THE CLEVELAND ELECTRIC ILLUMINATING COMPANY

April 26, 1982

Perry Nuclear Power Plant
Docket Nos. 50-440; 50-441
Response to Draft SER
Containment Systems Branch

FIGURE A
RIGHT HAND CO-ORDINATE SYSTEM
UTILIZED FOR BIO WALL
ANNULUS PRESSURIZATION LOADINGS

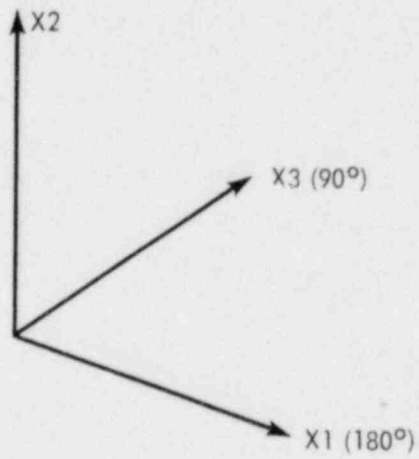
- c) Provide the projected area used to calculate these loads and identify the location of the area projections on plan and section drawings in the selected coordinate system. This information should be presented in such a manner that confirmatory evaluations of the loads and moments can be made.

- d) Provide the peak and transient loadings on the major components used to establish the adequacy of the supports design. This should include the load forcing functions (e.g., $f(t)$, $f_x(t)$, $f_y(t)$) and transient moments (e.g., $M(t)$, $M_x(t)$, $M_y(t)$) as resolved about a specific, identified coordinate system.

- c. The contribution to the total design force or moment loading from any individual node may be evaluated using the dimensions and coordinate system provided in Part d), plus the design nodal pressure information provided in Tables 6.2-12, 6.2-13, and Figures 6.2-29 and 6.2-30.
- d. Force and moment components on the biological shield wall were evaluated based on an inside diameter of 13'-9½". The coordinate system is as shown in Figures B and C. Peak resultant shears and moments for the design loading time steps are given in Figure D. Transient force and moment components about the X1 and X3 axes are shown in Figures E.1 through E.8.

Note that since the recirculation line breaks occur on a major axis of the coordinate system [recirc. suction at 0° (X1) and recirc. discharge at 90° (X3)] net transient force and moments about the second axis will be zero. Resultant shear and moment for the feedwater break can be obtained by using the SRSS method of the individual components.
